Residences of South Brookline Transportation Peer Review Responses

I. Peer Review (BETA) : Received 3/21/14

New Site Trips

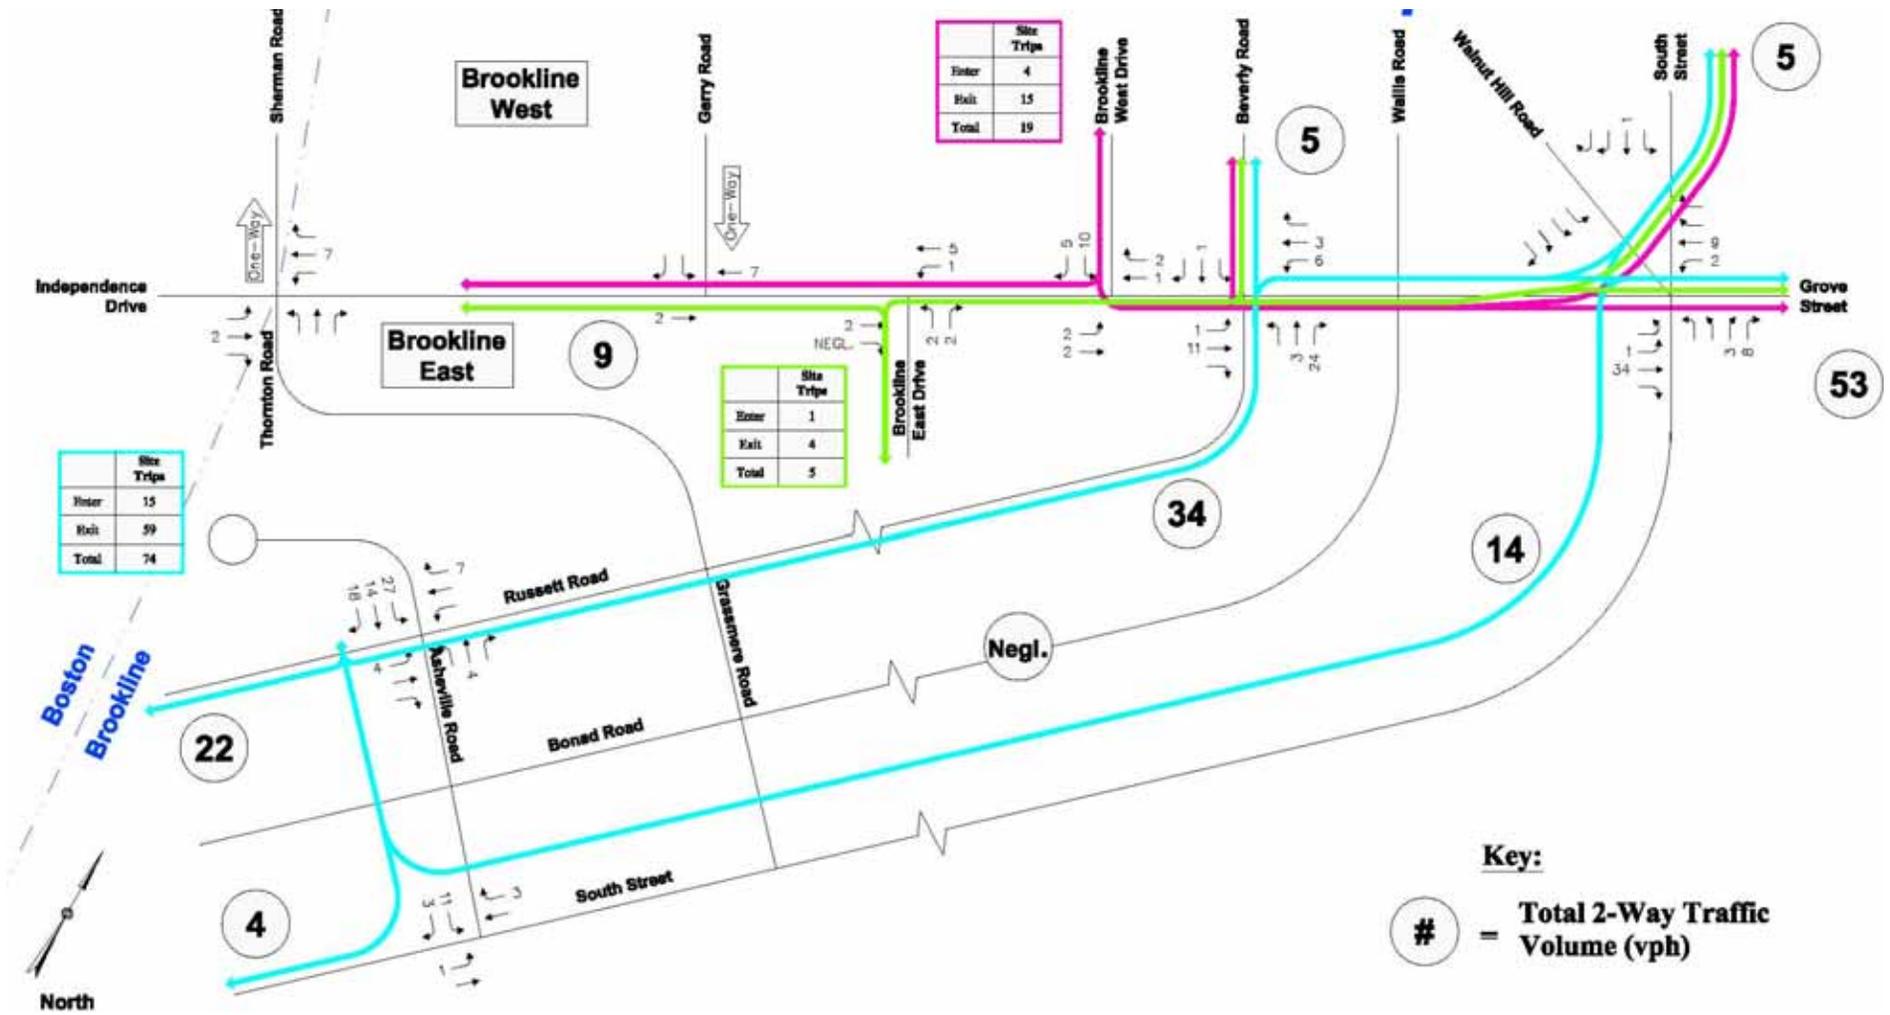
#22 – VFW Parkway/Independence Drive

- The anticipated impact to the VFW Parkway/Independence Drive intersection in the City of Boston is inconsequential and immaterial (less than 1 additional vehicle trip every 5 minutes along the Independence Drive approach to the intersection).

AM Peak Hour Site-Generated Trips

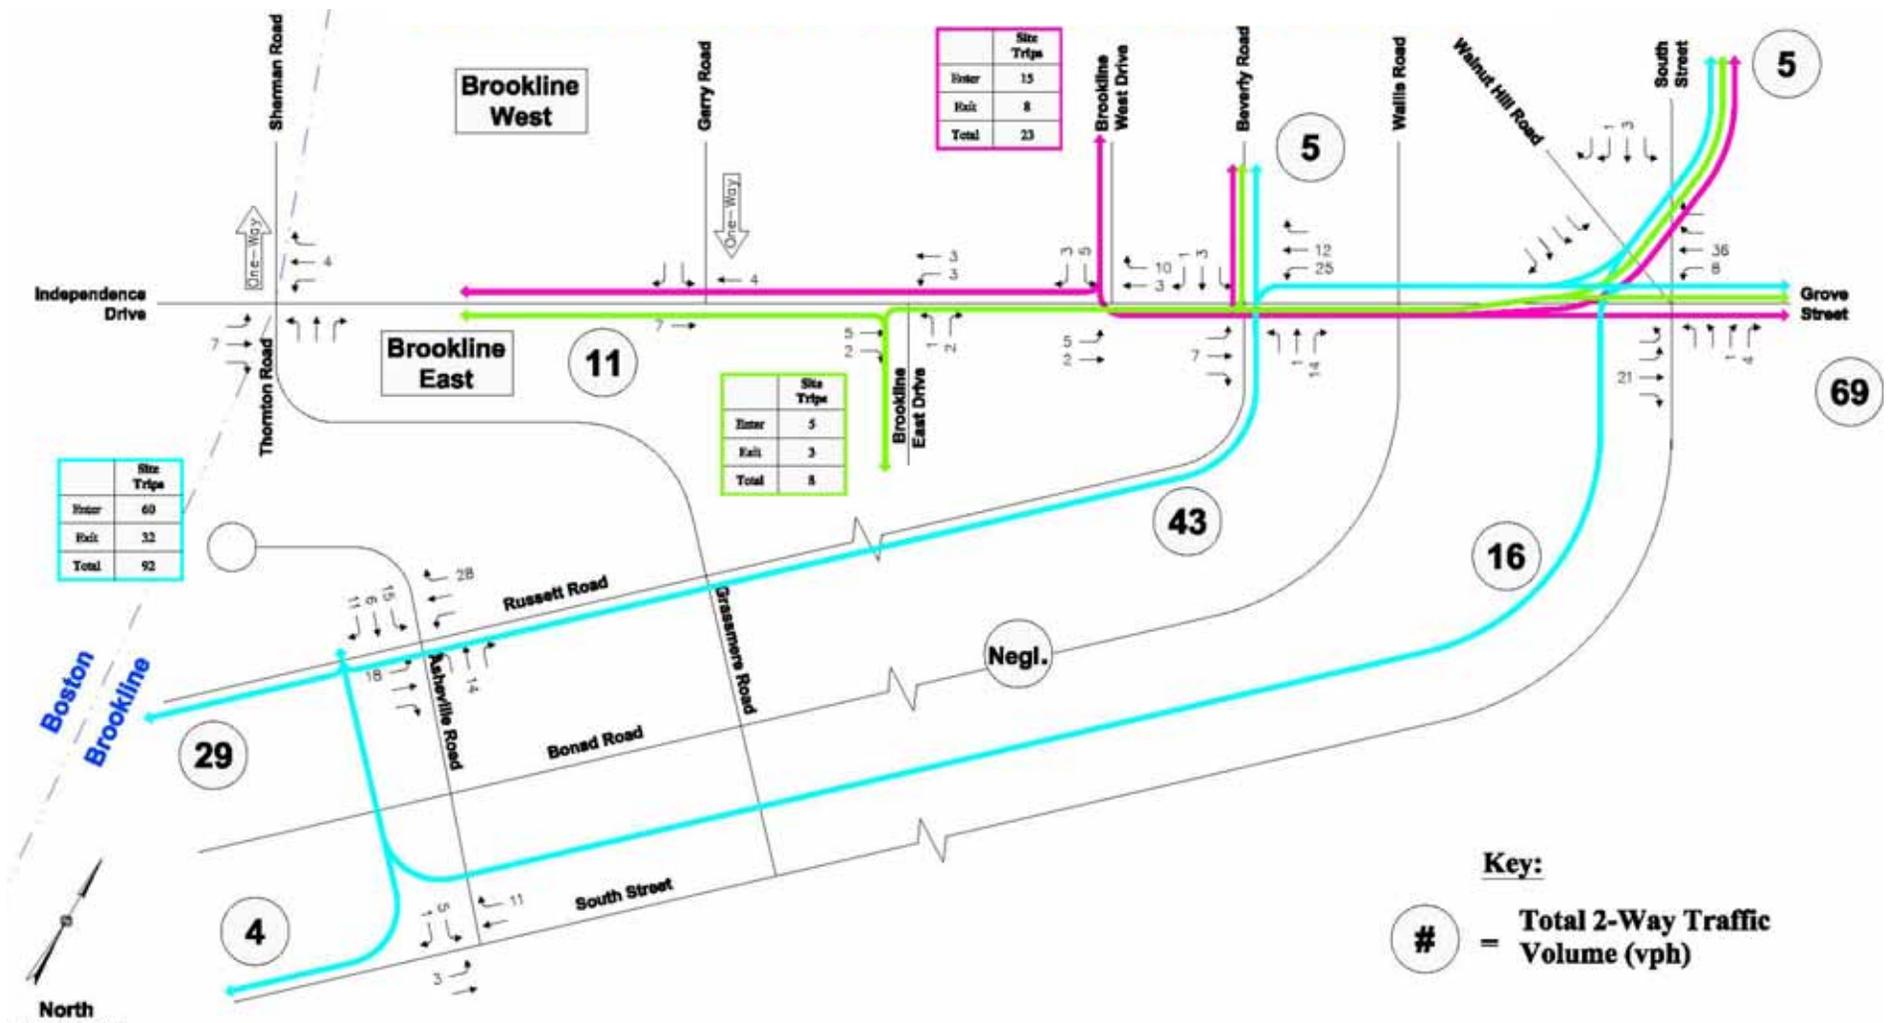
#23 – Asheville Access Cut-Through Traffic

- As previously discussed, the trip distribution methodology is appropriate and the resulting trip increases on area neighborhood streets are modest and represent 1 additional vehicle or less every 1 to 2 minutes during peak hours.

Figure 5-1. Types of Cul-de-Sacs and Dead-End Streets

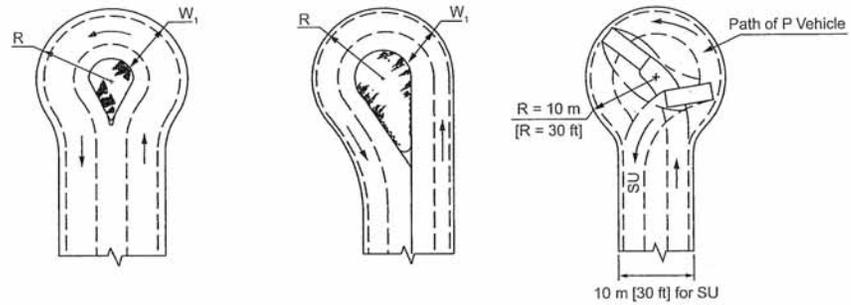
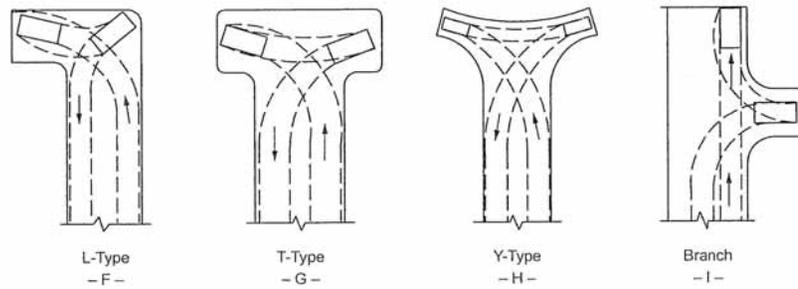
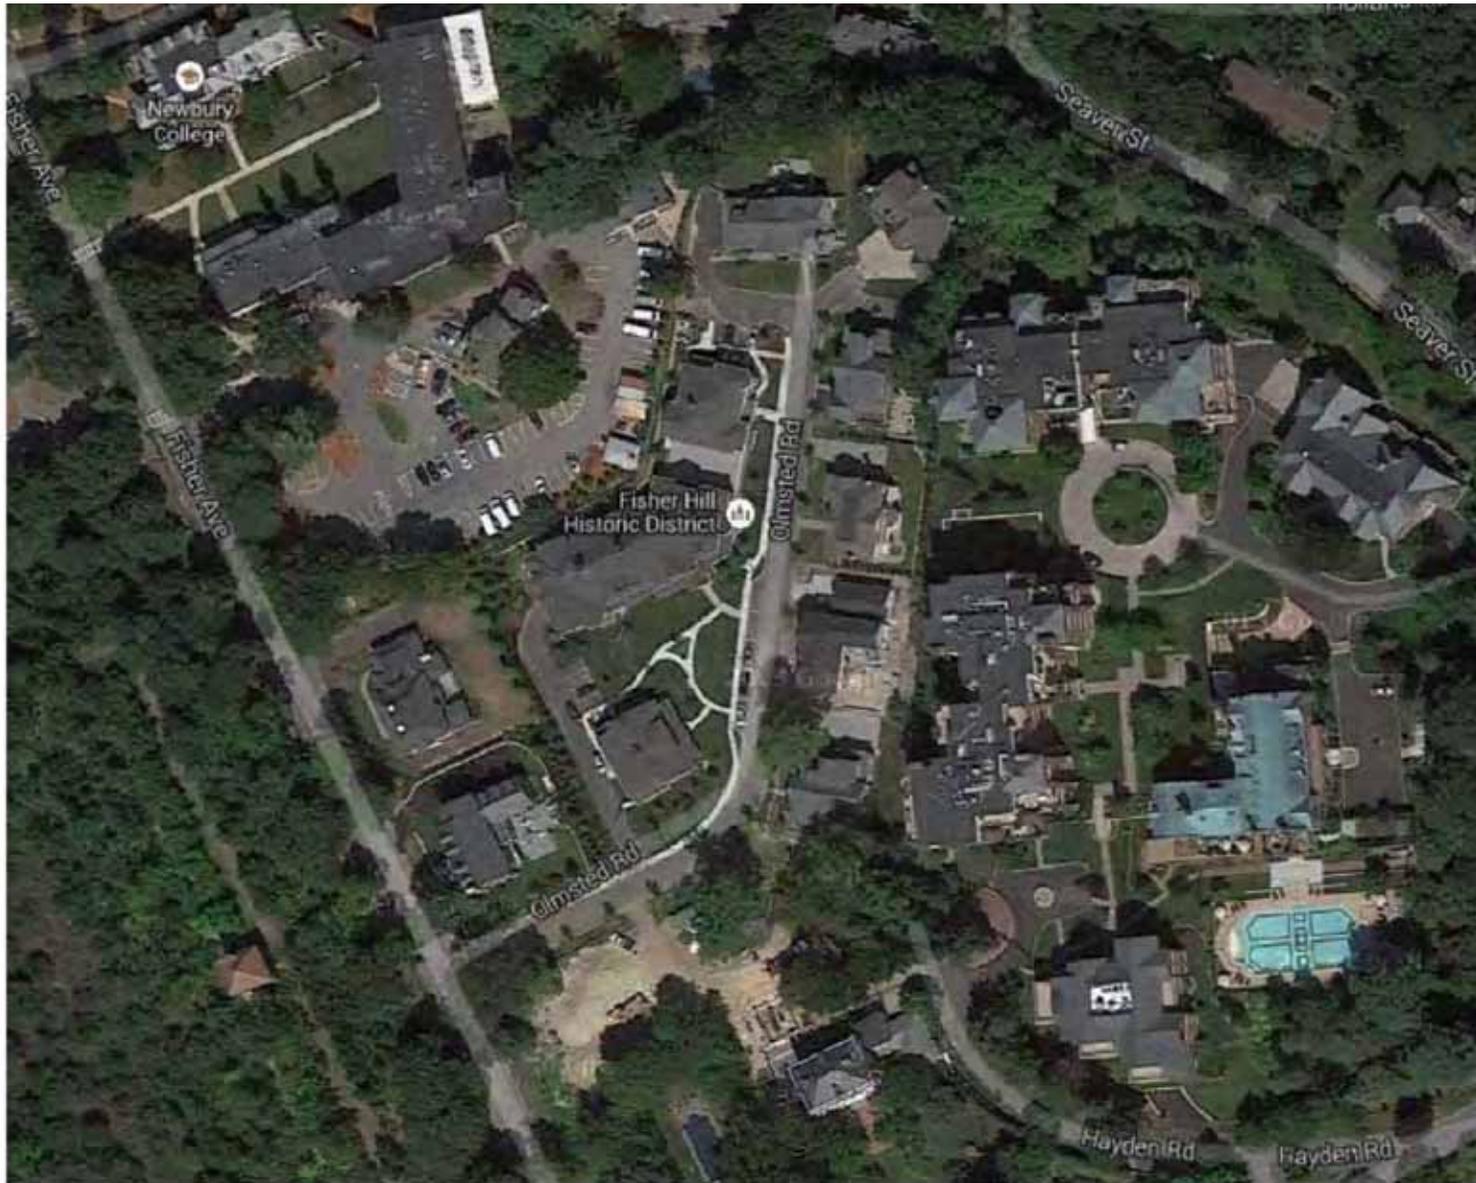
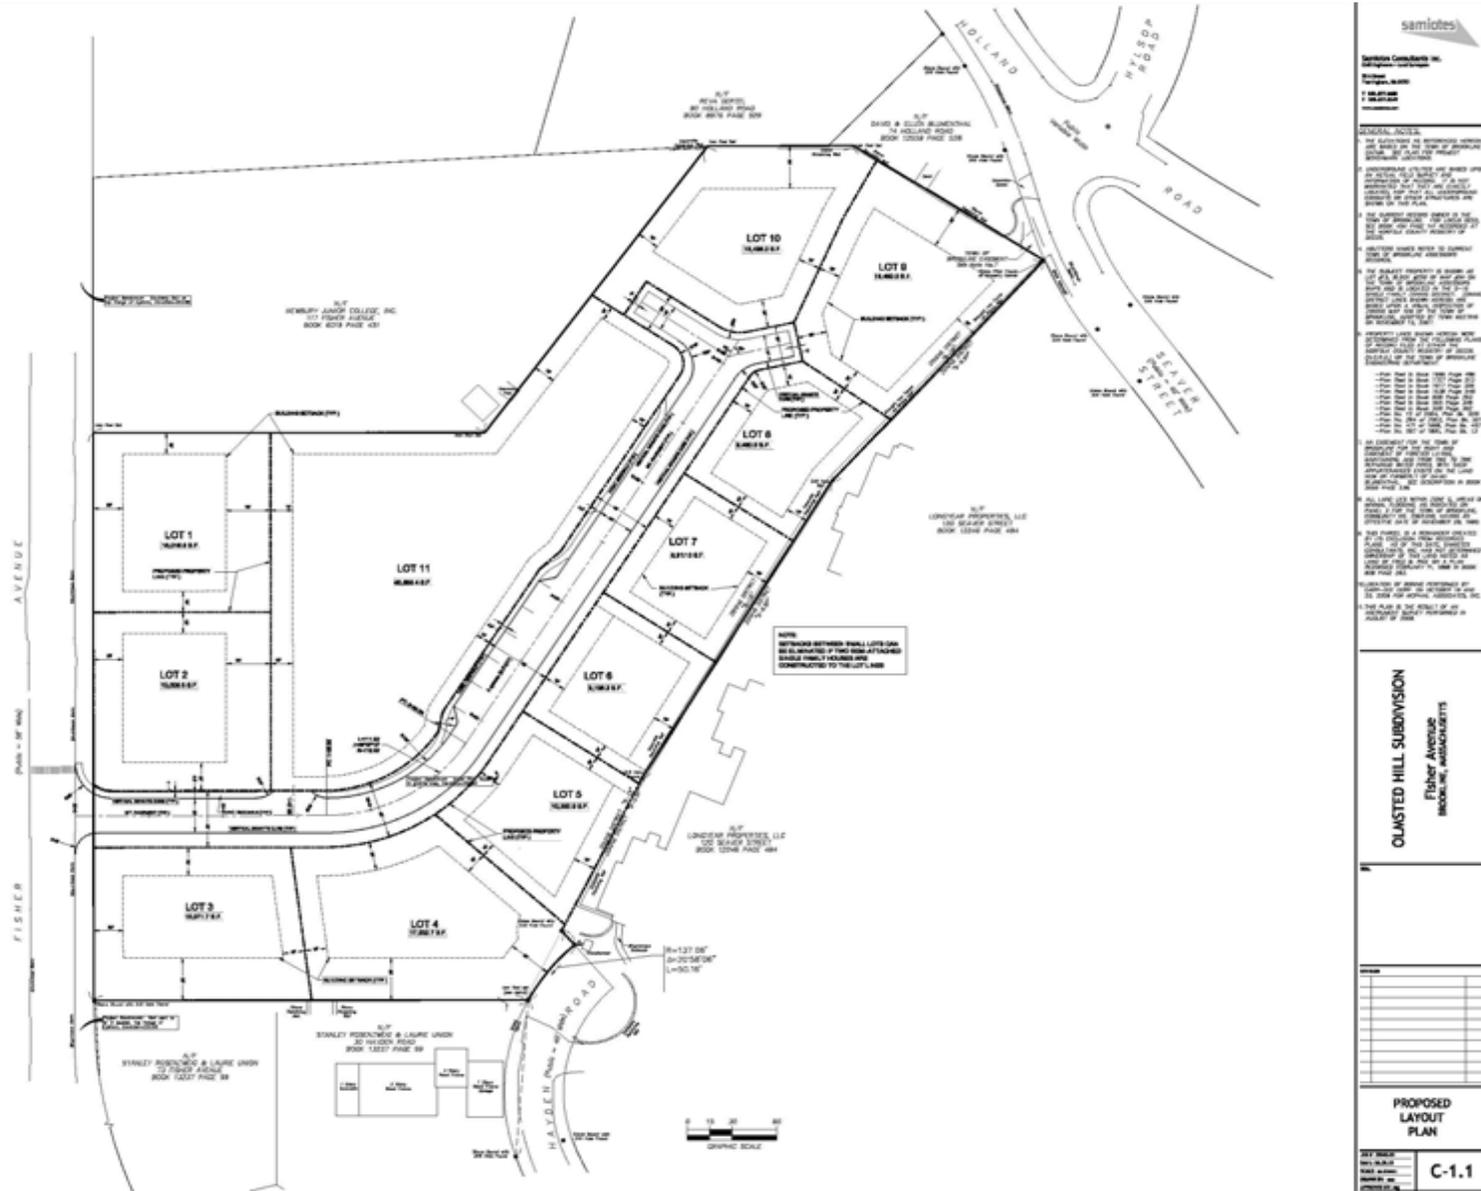
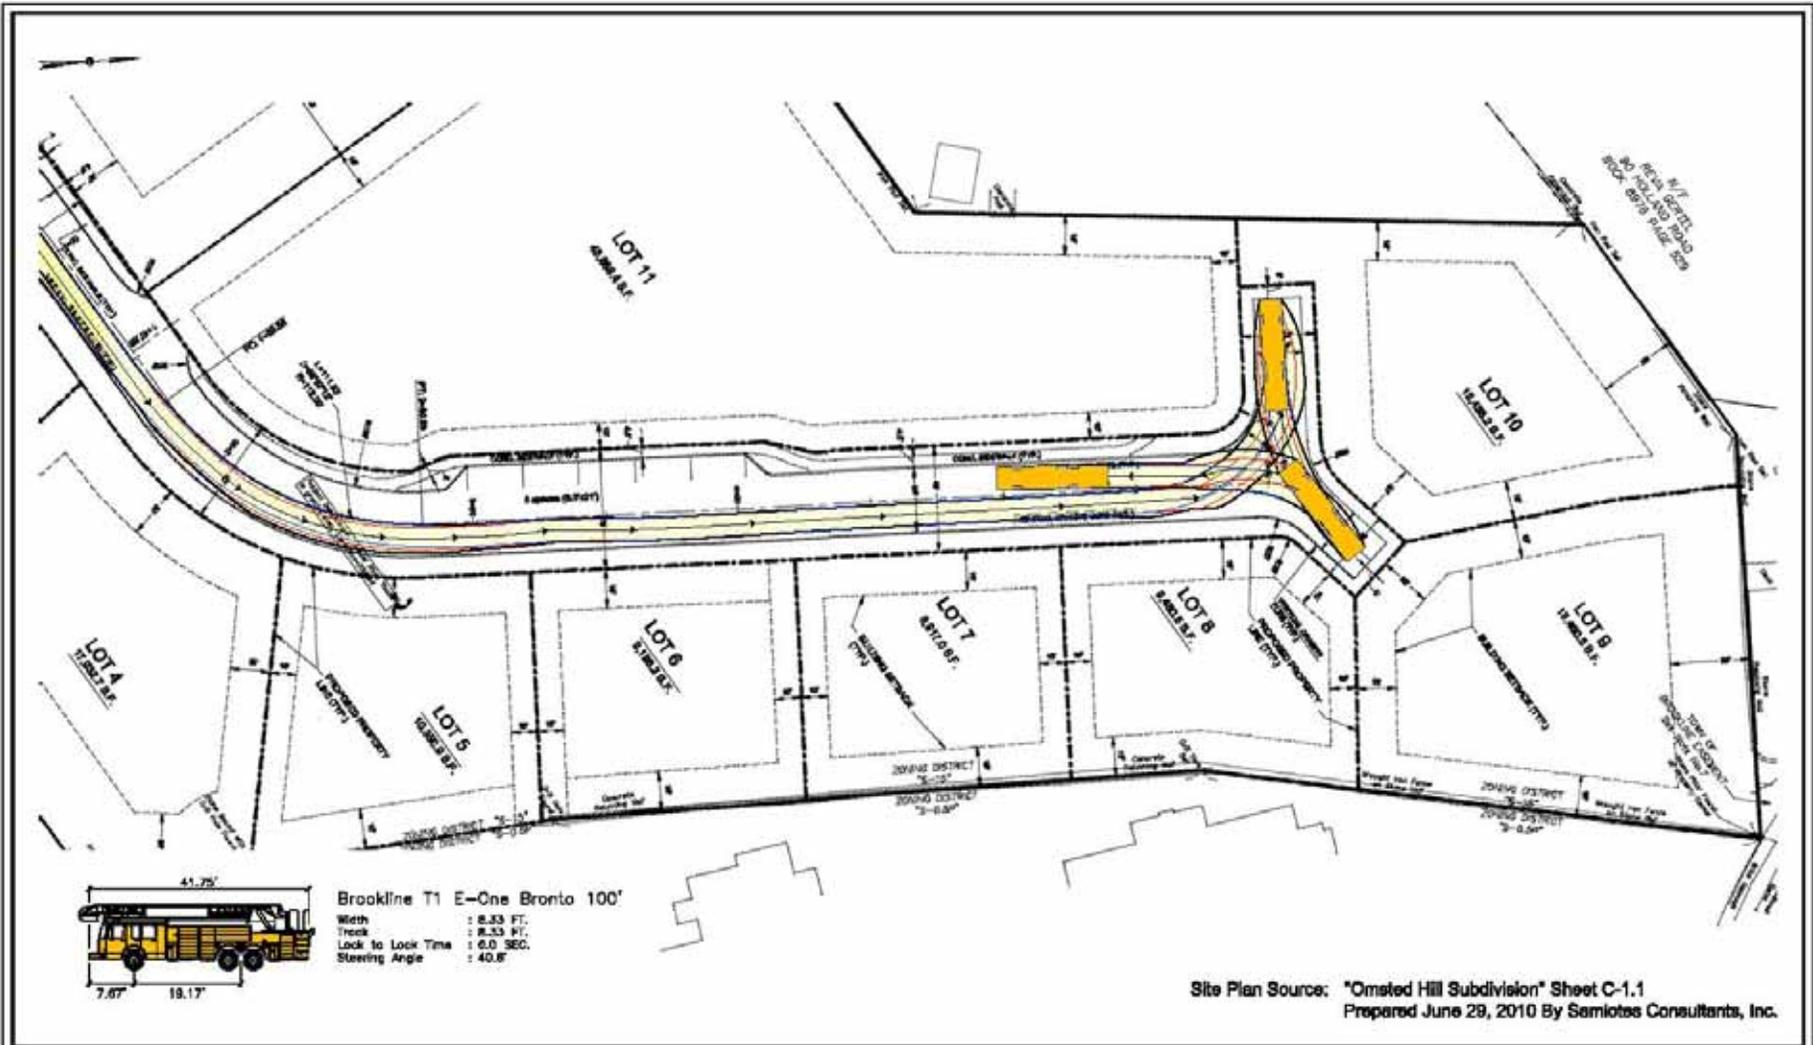
#33 – Hammerhead Design

- The proposed hammerhead roadway design will properly accommodate emergency vehicle maneuvering requirements and is an acceptable roadway design.
- AASHTO guidance on cul-de-sac and hammerhead design principles are applied.
